Whine Noise from Rear of Vehicle

YEAR(S)	MODEL(S)	ADDITIONAL INFORMATION
2019 - 2023	Tacoma	Body Type(s): Double Cab

Some 2019 – 2023 model year Tacoma Double Cab vehicles may exhibit a whine noise from the rear of the vehicle. This condition may occur while driving around 50 mph (80 kph) at constant speed, slight acceleration, or slight deceleration. This condition may be caused by rear differential vibration transferring through the chassis and body. Follow the Repair Procedure in this bulletin to address this condition.

Figure 4.

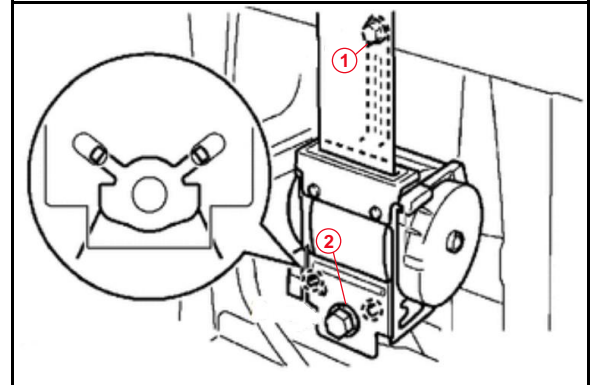
F. Torque the seat belt bolts.

Bolt A

Torque: 12.5 N*m (127 kgf*cm, 9 ft*lbf)

Bolt B

Torque: 42 N*m (428 kgf*cm, 31 ft*lbf)

Figure 6.

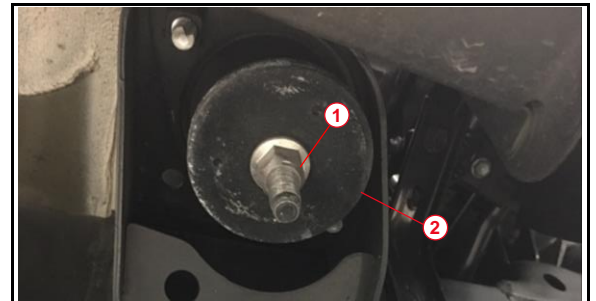
A. Remove the No. 3 cab mount nut (17 mm) and left-hand and right-hand cab mounting cushion stopper.

Figure 7.

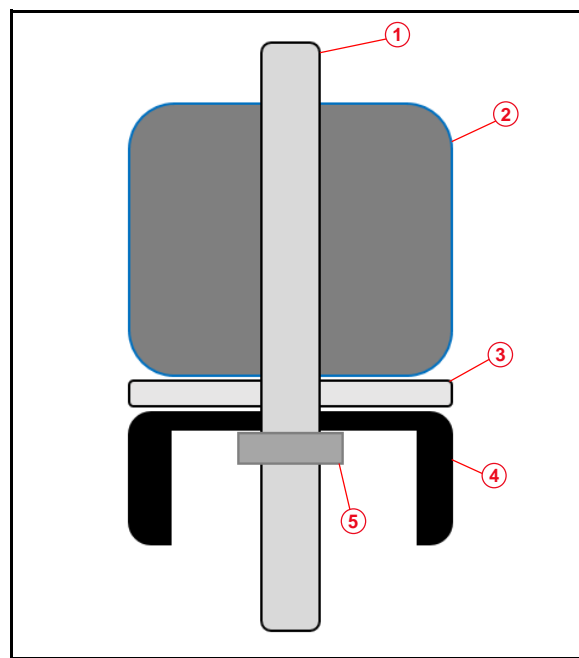
- B. Install the NEW cab mounting cushion stopper and the NEW frame dynamic damper to the right-hand and left-hand cab mount.
- C. Retighten the cab mount nut.
Torque: 45 N*m (459 kgf*cm, 33 ft*lbf)
